Subject: Indian Point 3 Nuclear Power Plant
Docket No. 50-286
Additional Information on WCAP-9117

This letter responds to Mr. Schwencer's April 16, 1980 letter requesting additional information to continue the review of WCAP-9117, "Analysis of Reactor Coolant System for Postulated Loss of Coolant Accident: Indian Point 3 Nuclear Power Plant," which was submitted on June 15, 1977 by Consolidated Edison.

ATTACHMENT 1

FIGURE 1

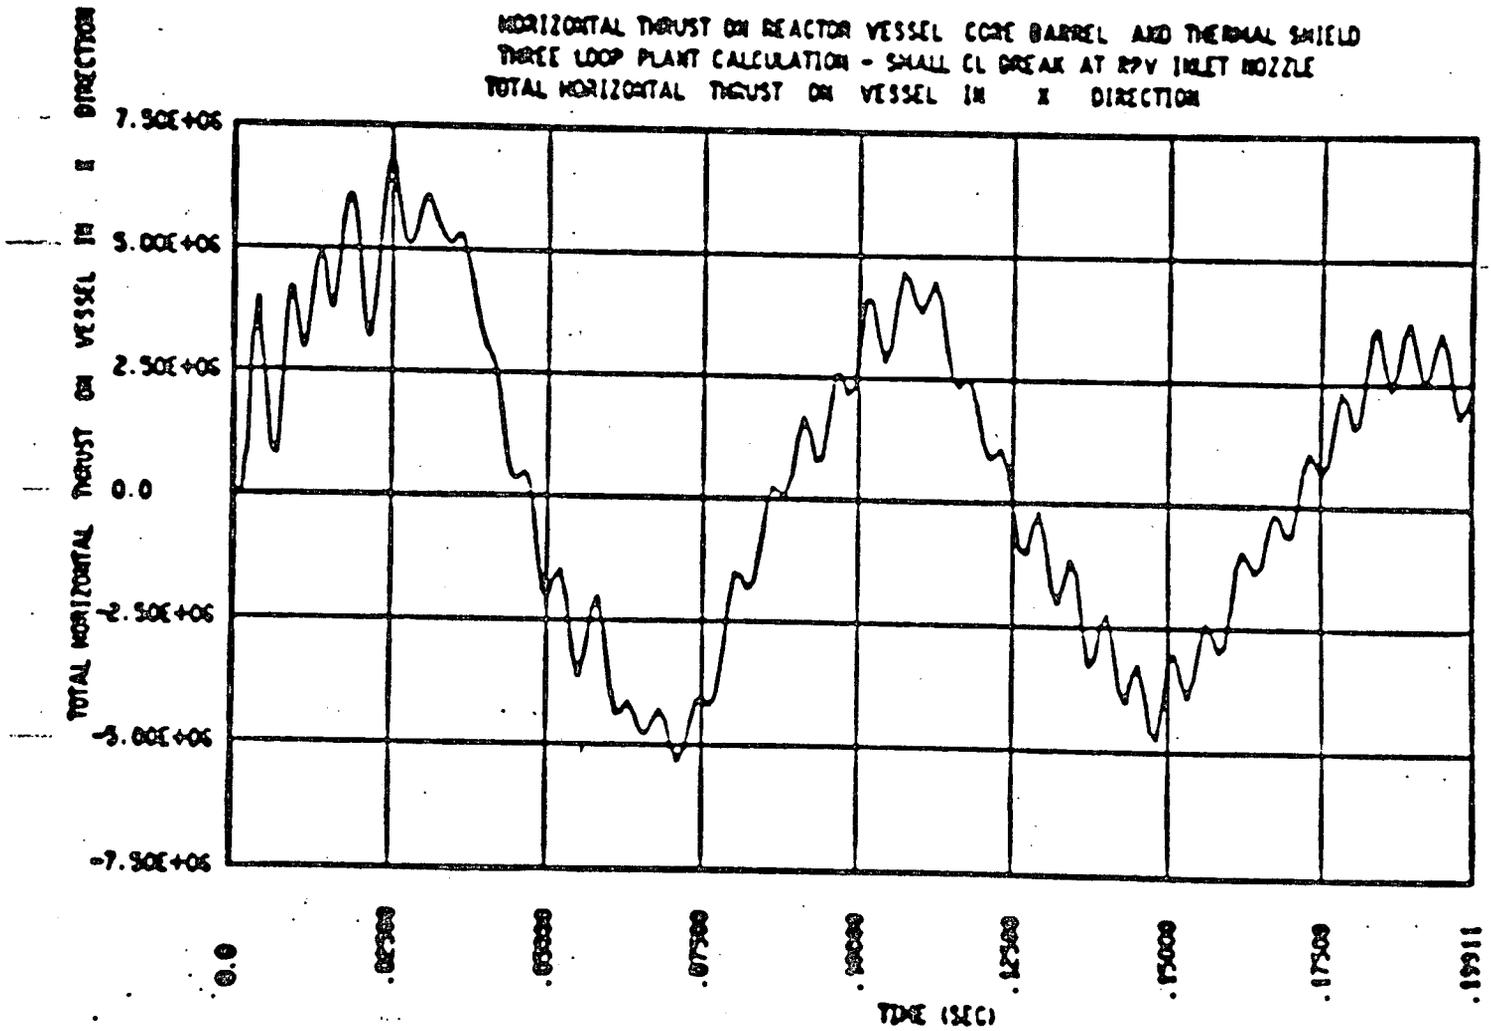
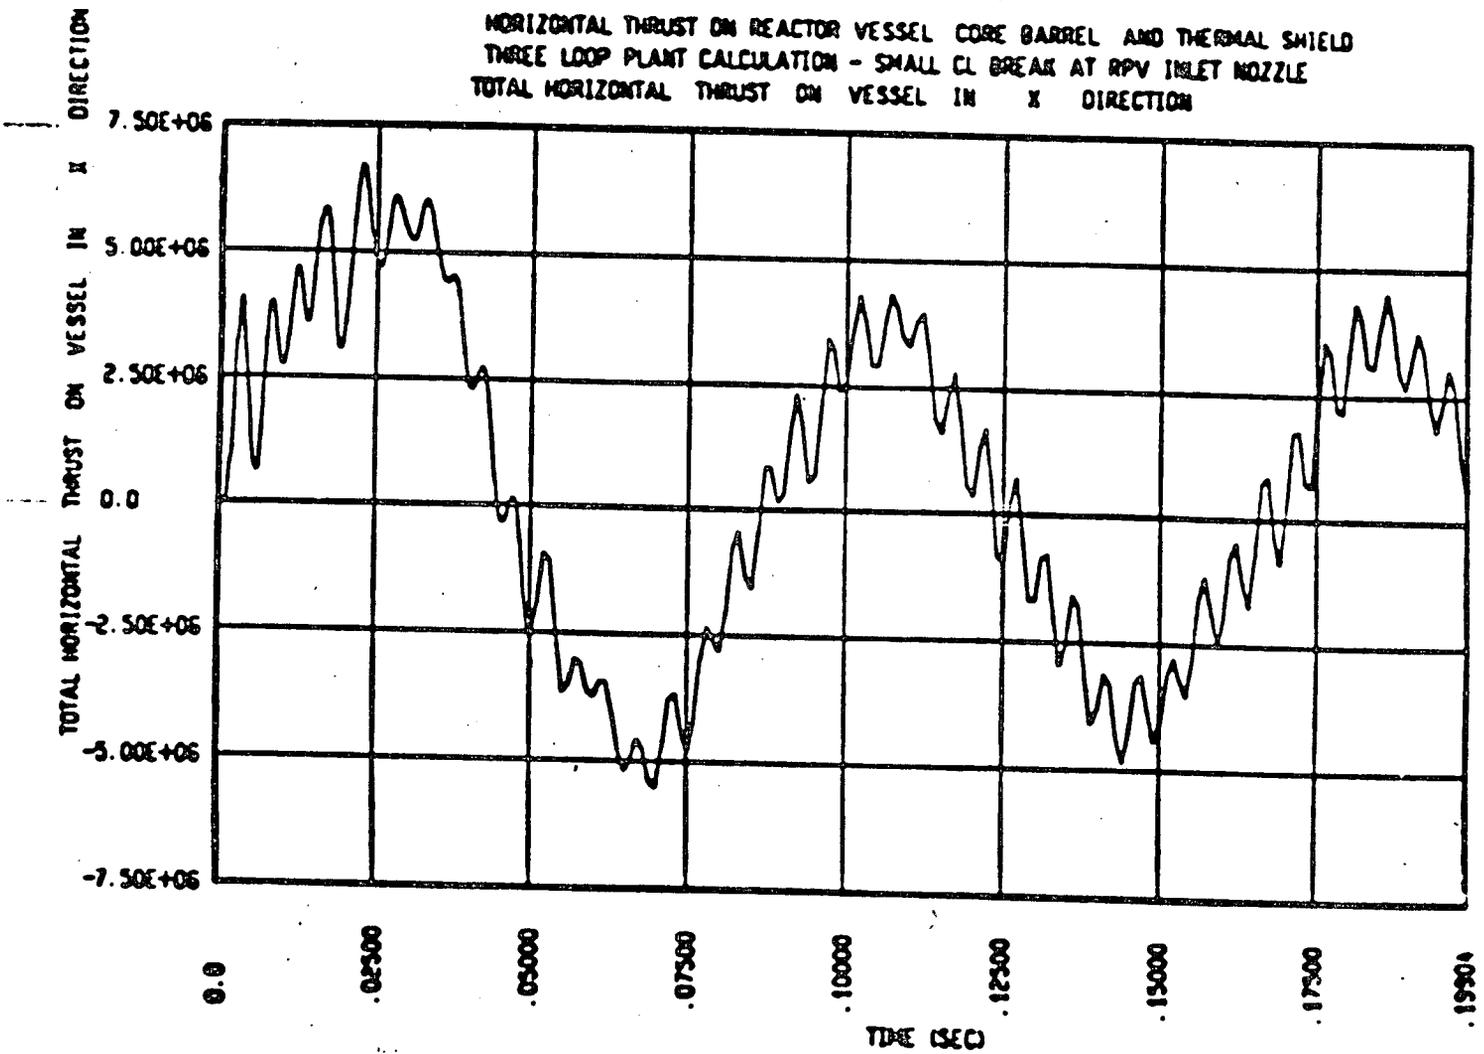
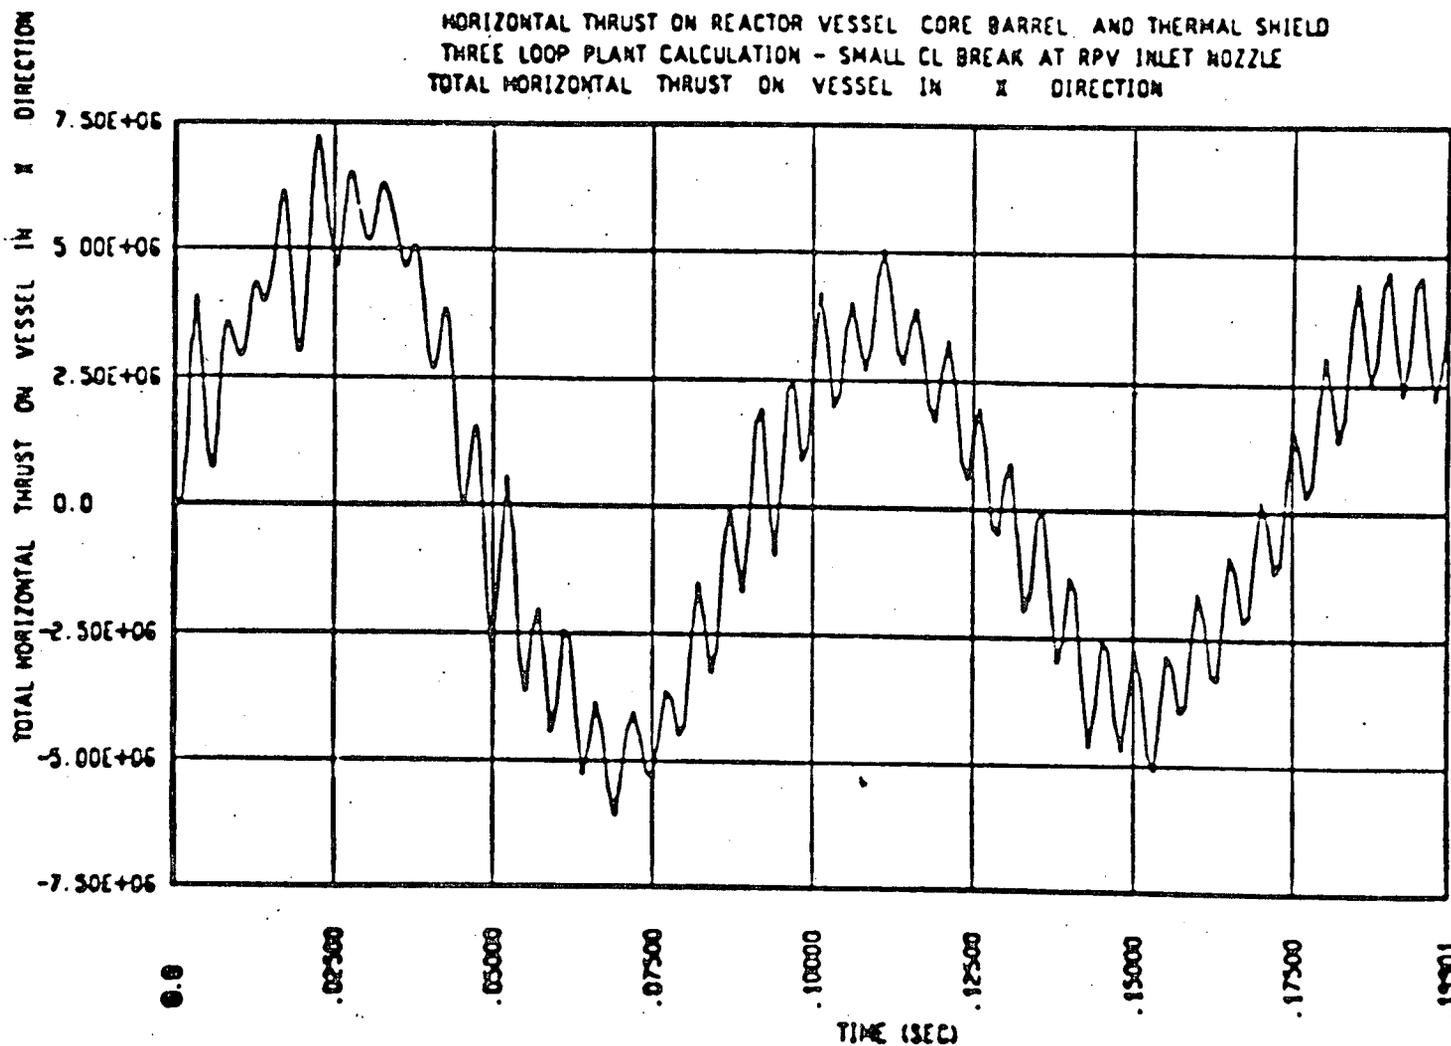
2. What lower plenum radial distance was utilized in the MULTIFLEX representation of the low plenum region of the Indian Point 3 model? Specifically, the comment, Item 2, on Page 12 of the NRC SER on WCAP 8708 should be addressed.

3. What sonic velocity was used in the MULTIFLEX of the Indian Point 3 model? Specifically, the comment, Item 1, on Page 11 of the NRC SER on WCAP 8708 should be addressed.

In the Indian Point No. 3 MULTIFLEX hydraulic model, the equivalent piping network representation of the lower plenum region does not correspond to the NRC modified lower plenum model described on page 12 of the Safety Evaluation Report. Also, the sonic velocity data utilized in the Indian Point No. 3 MULTIFLEX analysis corresponds to the original, uncorrected wave speed.

Parametric studies performed during the NRC review of the MULTIFLEX code demonstrated, however, that the inclusion of a more representative radial transport distance in the lower plenum model and the utilization of updated sonic velocity data results in a maximum of 5% increase in peak total horizontal hydraulic force (THF) on the vessel wall.

In order to further demonstrate the small effect these two modifications have on the hydraulic force, we have performed additional sensitivity studies which consider a limited-displacement area, guillotine-type break at the RPV inlet nozzle. The results of these parametric studies are shown in Figures 1 through 3, which are the THF time-history plots for the three different cases. The peak THF's and the corresponding times they are attained in the transient are given below:

<u>Figure</u>	<u>THF (x 10⁶ lb_f)</u>	<u>Time (Msec)</u>
1	6.786	24.9
2	6.689	22.6
3	7.216	22.5

Comparing Figures 1 and 2 shows that the utilization of the corrected sonic velocity data produced a small reduction (~1.4%) in the maximum THF. A comparison of Figures 1 and 3 demonstrates that the inclusion of a more representative lower plenum model and updated sonic velocity data results in a small increase (~6.3%) in the peak THF. Notice, also, that in all three cases the major forcing function frequency is unchanged.

The results of these additional sensitivity studies support the findings disclosed during the NRC review of the MULTIFLEX Code, i.e., they further demonstrate that consideration of the above two MULTIFLEX modifications has an insignificant effect on the magnitude and frequency of the hydraulic forcing function. In addition, since the internals forces are one of three different inputs required for the evaluation of the vessel support loads and fuel grid impact loads, this means that these two MULTIFLEX modifications would produce an even smaller effect on the resultant mechanical loads.
